Product Change Notification

Product Change Notification: E-16-014613

AMPMODU MTE HEADERS GPL 296

Change in circuit cavity features

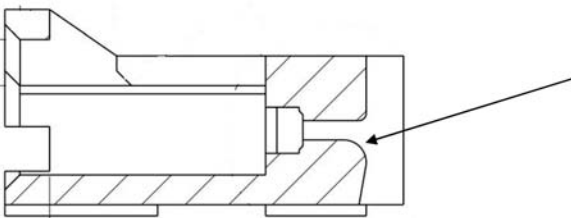
To satisfy customer demand for the capability of MTE headers to handle RoHS solder temperatures, TE Connectivity has retooled the MTE header product line to use high temperature compatible LCP molding material. These changes will result in the following product changes: 1) Housing material will change from high temperature nylon to LCP. 2) The header housing width will be reduced by 0.005 inches to accommodate the assembly process. 3) In order to consolidate some housing features, the contact cavity configuration will be changed slightly as shown in the attached sketch.
